Technical Bulletin

TB 0283 - Replacement of failed IDEC RH2B-UD Relays

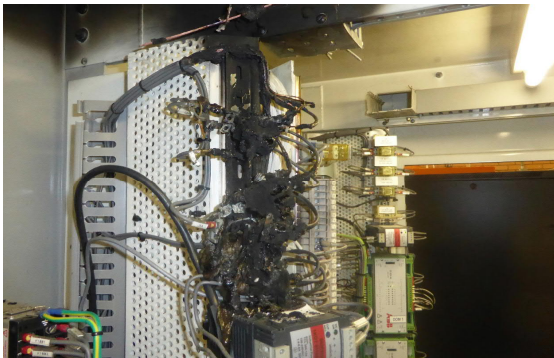
A recent fire at Mittagong ZS was started by an IDEC relay that was forced to break inductive coil current. A photo of the damage from the failed IDEC is shown below

Whenever a failed circuit breaker operation has resulted in a damaged IDEC relay, the relay and base must be replaced with an interposing relay with a magnetic blow-out contact whenever practical.
